**STAFF REPORT**

**Review of Turlock Irrigation  
District's 2018-2030  
Integrated Resource Plan**

August 2019 | CEC-200-2019-013

**Figure 2: Turlock and California Energy Commission Energy Forecasts  
2019-2030 (GWh)**

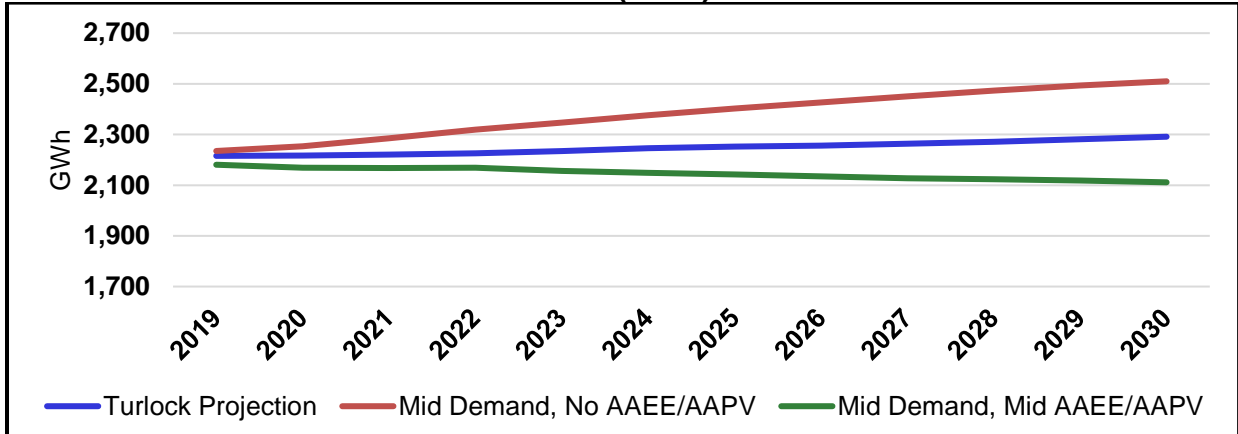
Distributed solar PV in Turlock's service territory grew by 47 percent annually between 2012 and 2017, from 5 to 35 MW. The utility projects continued solar capacity growth of 7.5 percent per year from 35 MW in 2017 to 87 MW in 2030. Energy produced by these resources is expected to increase from 67 GWh in 2019 to 145 GWh in 2030, which equals about 6.6 percent of forecasted energy load in 2030.

**Figure 3: Turlock and California Energy Commission Peak Demand Forecasts,  
2019-2030 (MW)**

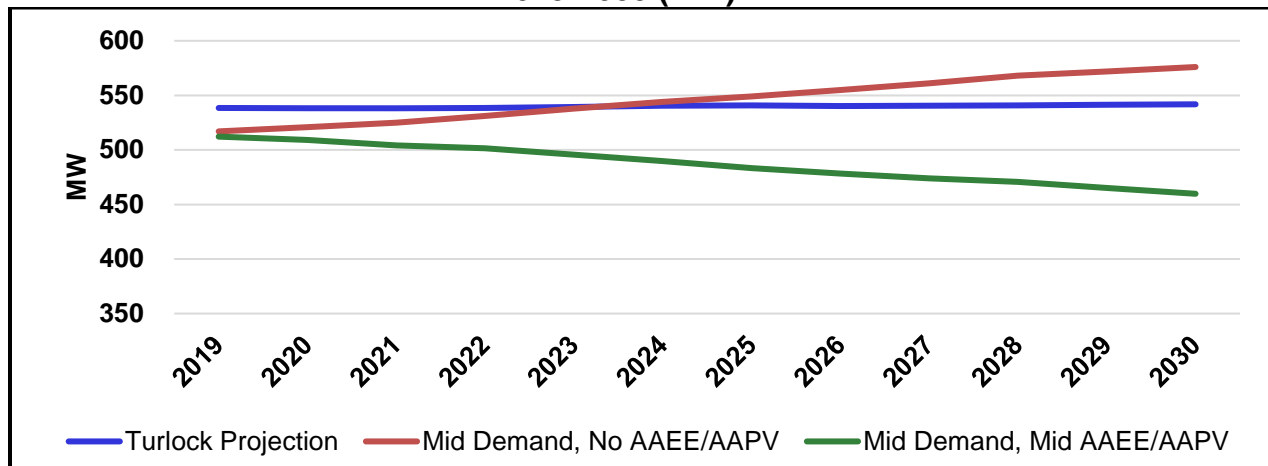
During the outer years of the planning horizon, the Turlock forecast is lower than the CEC's Mid Demand, No AAEE/AAPV forecast, but higher than the CEC's Mid Demand, Mid AAEE/ AAPV forecast. The CEC embeds committed energy efficiency savings in its forecast, while Turlock's forecast embeds committed energy efficiency and AAEE.<sup>13</sup> The disparity in the treatment of energy efficiency savings could explain some of the differences between the forecasts.

Turlock projects that distributed PV over the planning horizon will reduce its peak demand from 12 MW in 2017 to 41 MW in 2030.

**Figure 4: RPS Energy and RECs, 2019-2030 (MWh)**

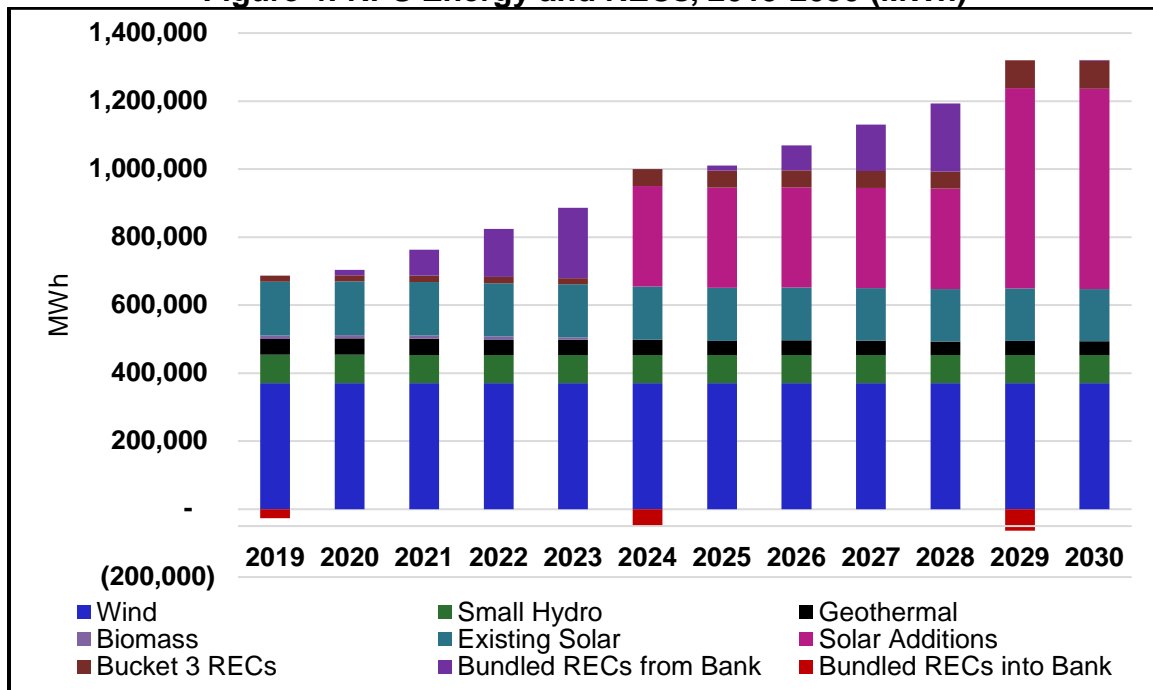
Current projections show Turlock producing more RECs than required in 2018 and 2019. Turlock added to its bank of RECs in 2018 and anticipates adding 27,000 MWh of RECs in 2019, shown as a negative entry in **Figure 4**. Turlock anticipates that the use of RECs will allow it to meet RPS requirements through 2023 without procuring renewable energy beyond existing utility-owned generation and resources currently under contract.

Beginning in 2020, Turlock intends to rely on banked bundled RECs from previous years to meet a share of procurement requirements in 2020 and during the 2021 to 2024 compliance period.<sup>25</sup> Turlock anticipates depleting the banked surplus of RECs by 2025 and needing to procure more renewable generation after that. To continue complying with the RPS during the planning period, Turlock would need to add about 300,000 MWh per year of new renewable resources in 2024 and another roughly 300,000 MWh in 2029. Although additional procurement is not needed until 2025, planning to acquire additional renewable resources in 2024 allows for forecast errors, potential delays in procurement, and flexibility in procurement timing based on market dynamics.

**Figure 6: Turlock Portfolio Comparison for 2019 and 2030 (MWh)**

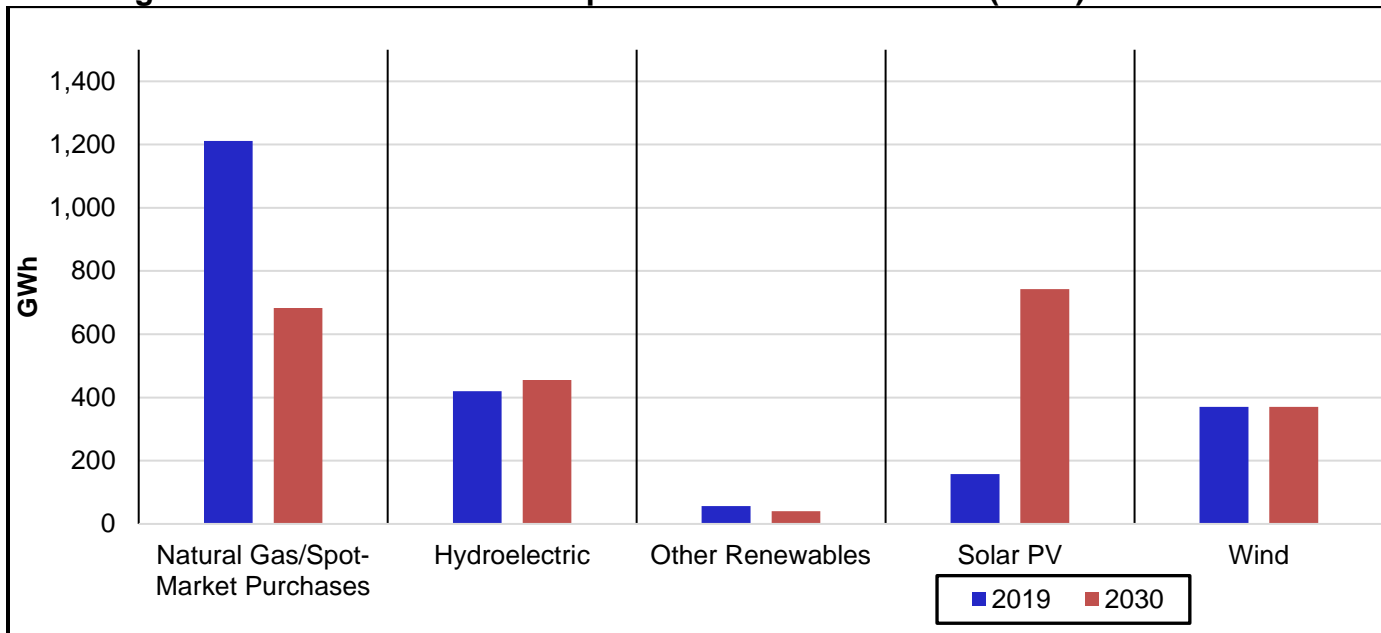
**Figure 6** shows Turlock’s portfolio transitions from natural gas to solar to meet the GHG emissions reduction target and RPS in 2030.<sup>36</sup> The renewable portfolio is diversified by fuel type (including solar, wind, and geothermal resources), and ownership or contract length, since the utility owns the Tuolumne Wind Project and small hydro plants and can choose any contract length for future solar additions. The natural gas component of the portfolio includes only existing utility-owned generation, leaving the utility flexibility in procuring additional resources to meet future energy and capacity needs.
